ADDENDUM NO. 1
TO THE BID DOCUMENTS
Main Street Sidewalk Improvement Project
CITY OF HOMER, ALASKA

Addendum Issue Date: April 22, 2022

Issued By: Janette Keiser, PE
Public Works Director
City of Homer

DATE: 4/11/2022 2:36 PM
 TIME: 2:36 PM
 SCALE: 1"=20'
 DESIGNED BY: NMO
 CHECKED BY: NMO
 DRAFTED BY: WP

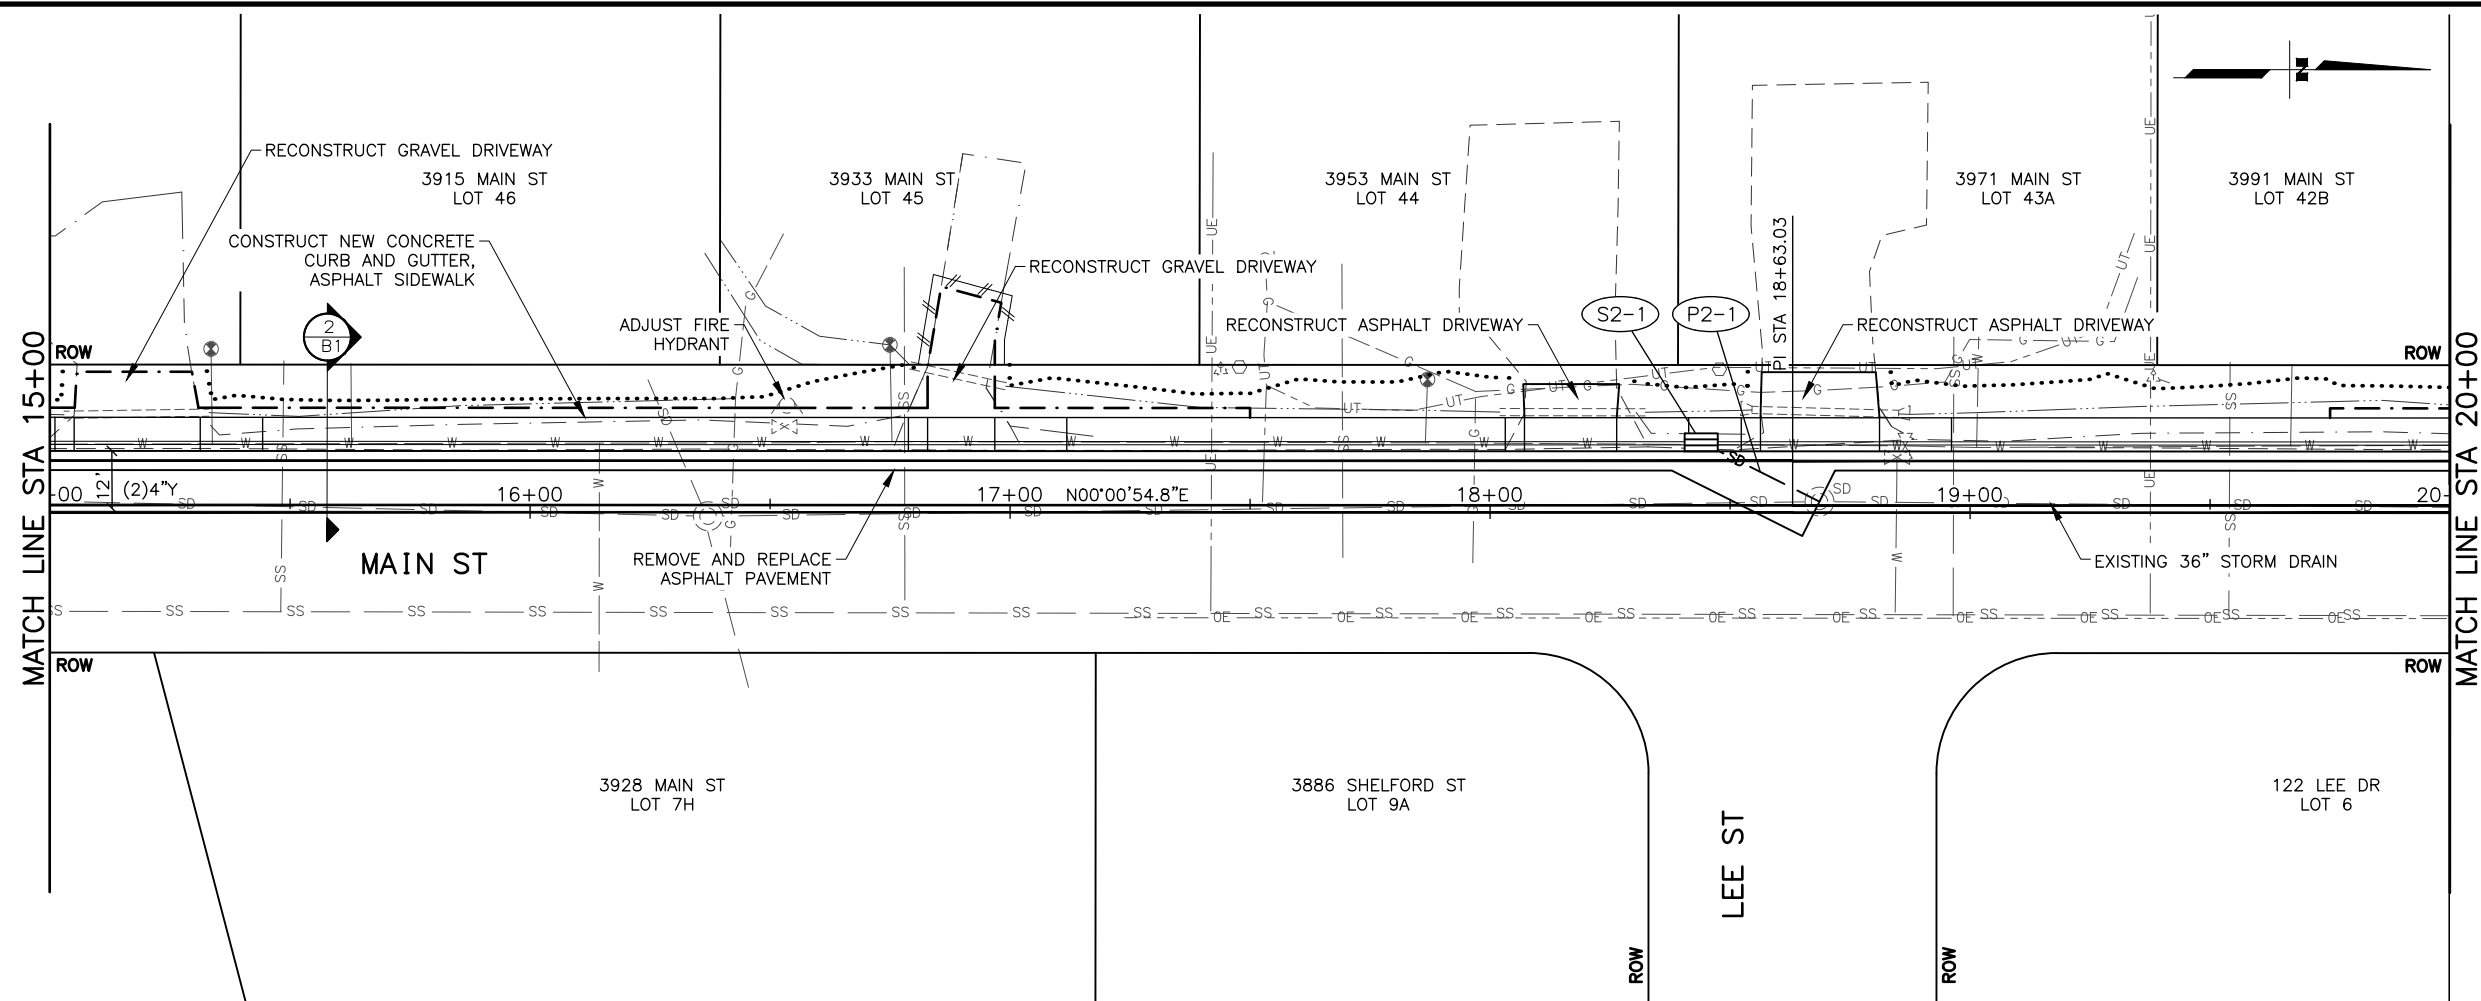
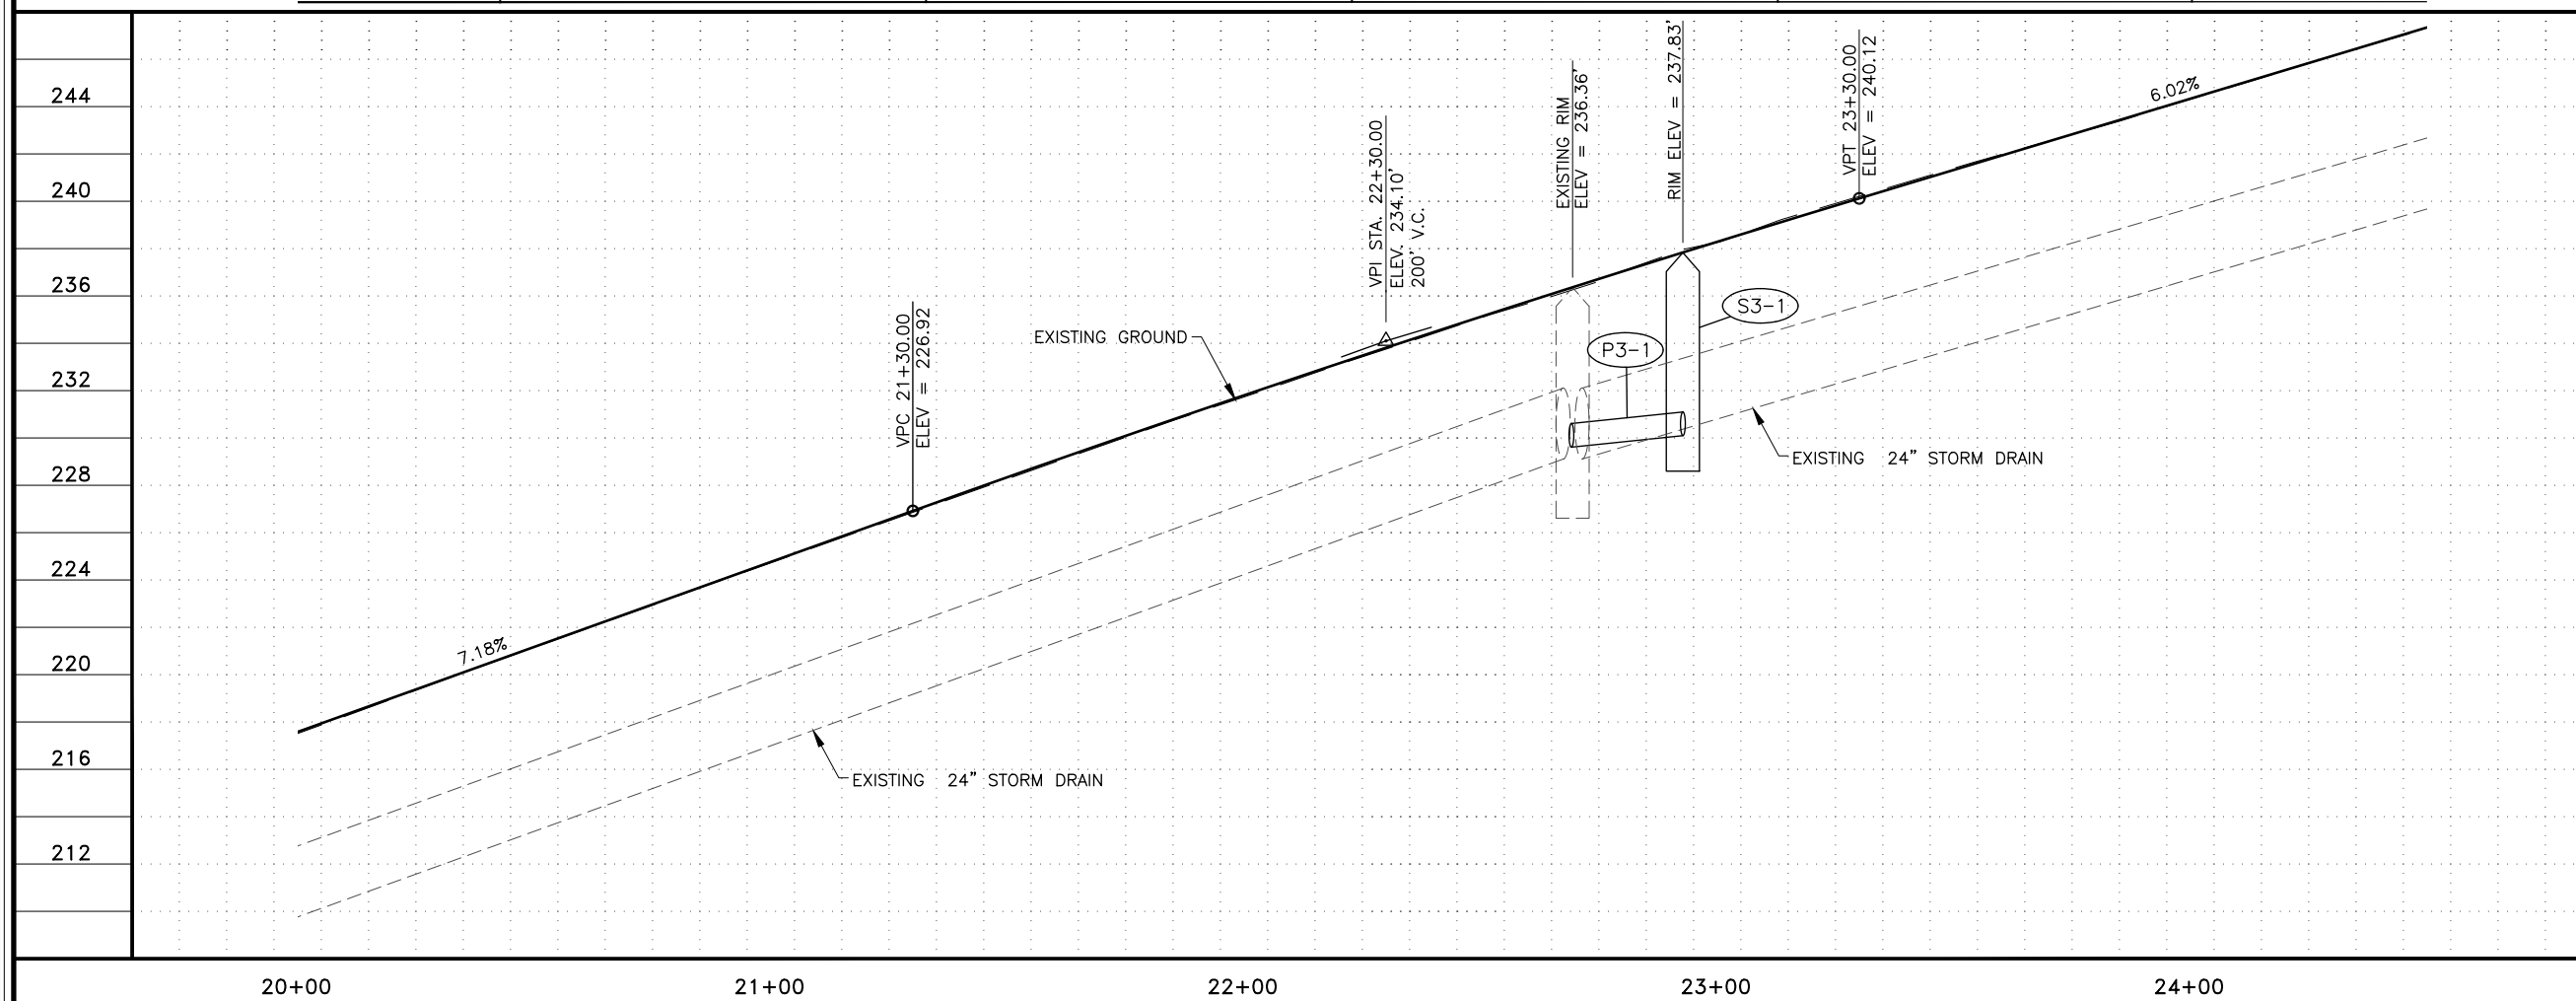
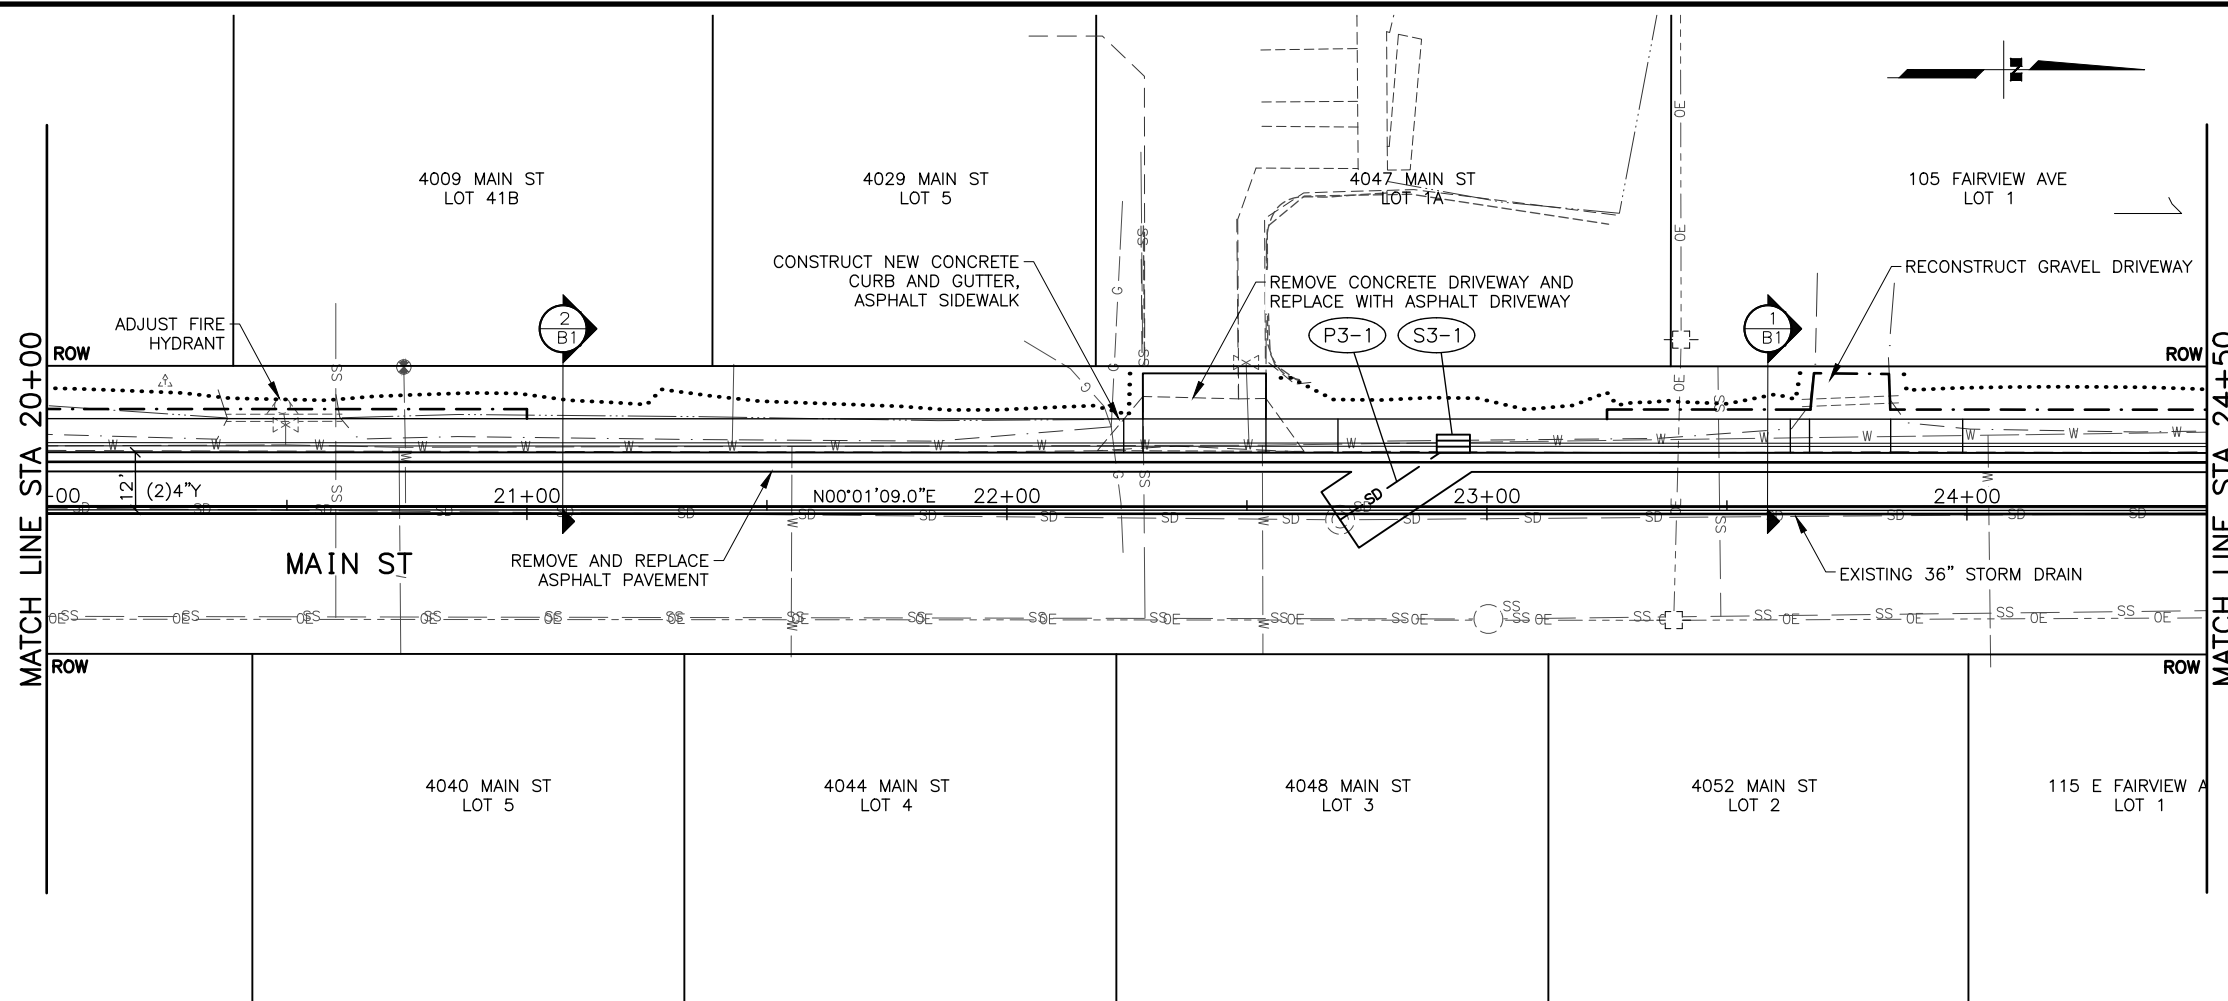
The City noticed that the existing storm drain pipe section from Pioneer Avenue to Fairview Avenue on sheets F1 – F4 of the plans has been mislabeled as 24” pipe when it is actually 36” pipe. The transition from 36” pipe to 24” pipe is made at the manhole closest to Fairview Avenue shown on sheet F4. Additionally, the City noticed that the invert elevations of the existing manholes were not indicated on the plans. To clarify both of these points, we have attached as-builts for the existing storm drain pipe. It should be noted that these as-builts use the NGVD 1929 datum rather than the NAVD 1988 datum used by the plans.
